DEFINITY[®]
Enterprise Communications Server
G3V4 (08.0.084.1)
Change Description

555-233-403
Comcode 108334822
Issue 1
September 1998

This Change Description describes the changes incorporated in DEFINITY Enterprise Communications Server (ECS), G3V4.08.0.084.1.

System Parameter Customer Options screen

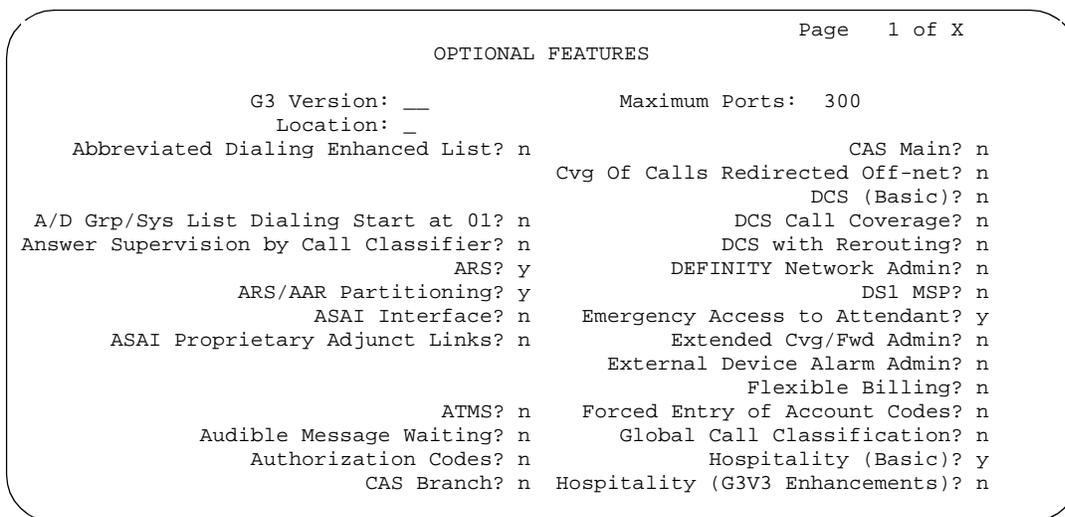
A new Location field on page 1 of the System Parameter Customer Options screen shows the location of the switch to be United States/Canada or all other locations.

The Location field is set to 1 for the United States and Canada. The Location field is set to 2 for all other locations, and allows the use of International Consolidation circuit packs and terminals in DEFINITY ECS International offers.
